MEETING OF THE UPPER THAMES RIVER CONSERVATION AUTHORITY HEARING COMMITTEE
THURSDAY, MARCH 18, 2021 – 1:00pm
Virtual Meeting Due to COVID-19 Pandemic

Re: Permit Application #27/20
Mills Award Drain
Township of Perth South
Our Job No. 218288

Drawing No.: 1 of 2

Subject: Addendum to (January 11, 2021) Hearing Report –
Section 28 Permit Application #27/20 for Proposed
Development in a Floodplain, Development in a River or
Stream Valley, Development Affecting the Conservation
of Land and Alteration to a Watercourse associated with
Mills Creek (aka the Mills Award Drain) - North and
South of Perth Line 29, Township of Perth South.

STA 0+615 POOL & RIFFLE
SCALE: N.T.S.

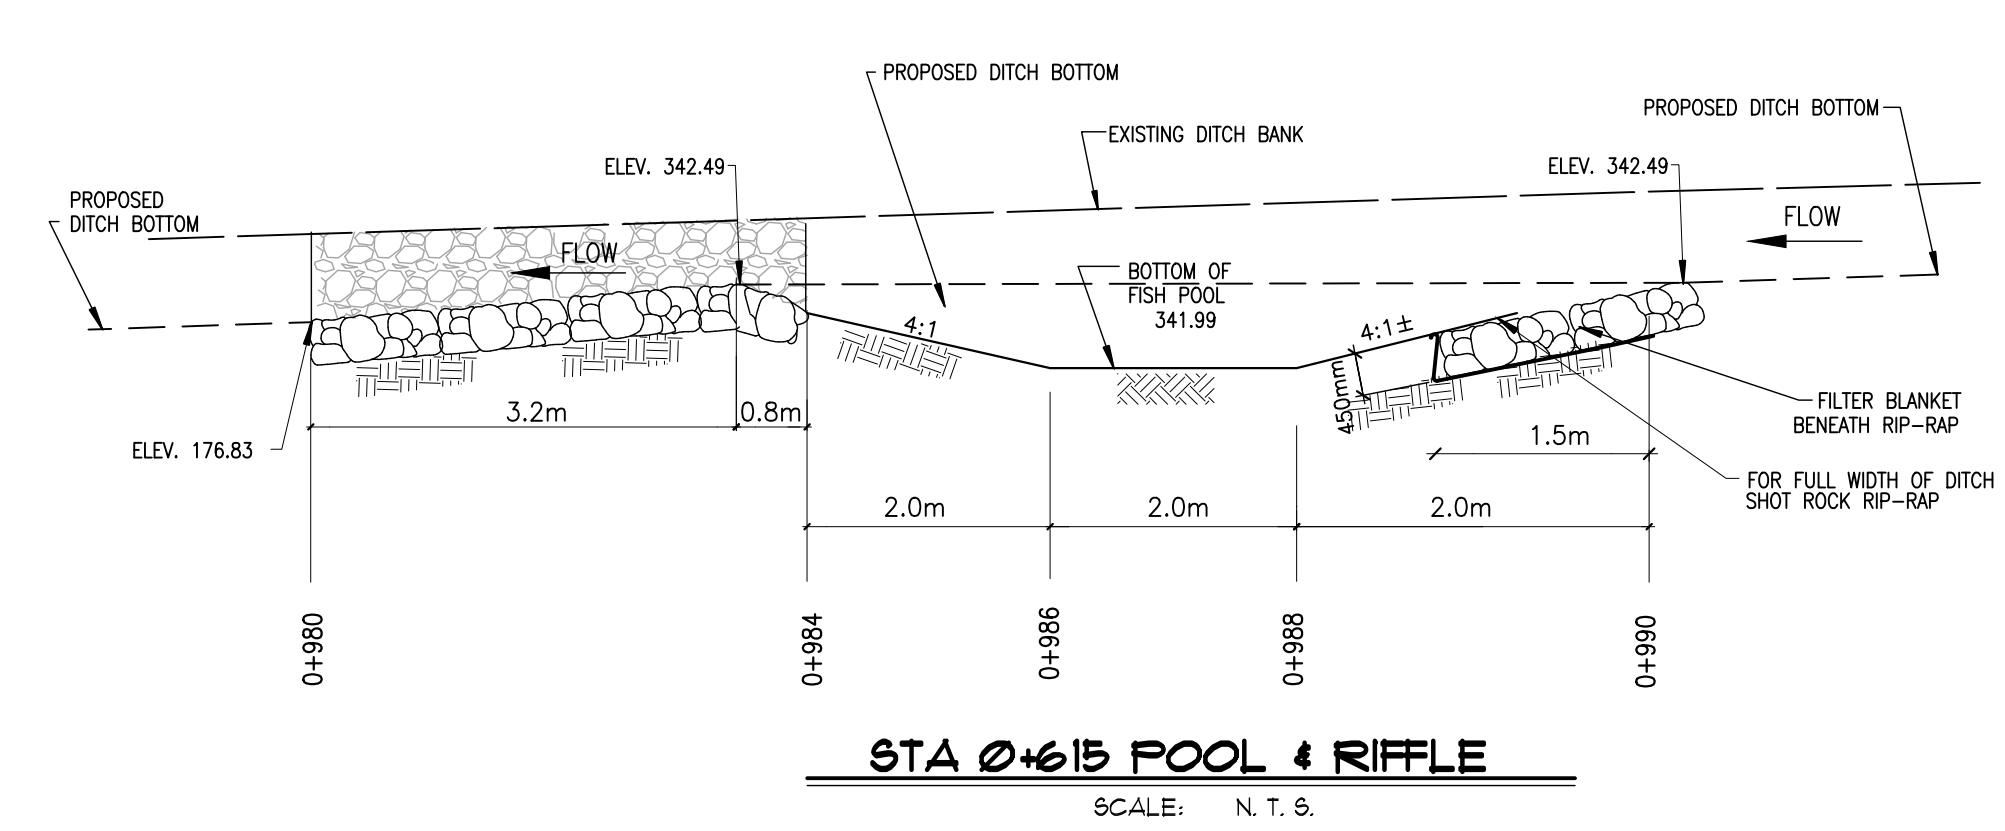
- vii. The current proposal is suggesting the inclusion of two stilling basins (pools and riffles), presumably as compensation (Net Environmental Benefit) measures. One stilling basin is proposed at the outlet (1+000) and we note it is a standard design BMP to include a stilling basin at the outlet of any pipe for the purpose of reducing erosion/scour. The second pool and riffle area is proposed further downstream (0+600). From photos previously provided in the January 11, 2021 Hearing Report it is noted that there are already well defined riffles and pools at this location. While the inclusion of the riffles and pools are beneficial in drainage design BMPs, at this location they would not provide any measurable compensation for the loss of the open watercourse.
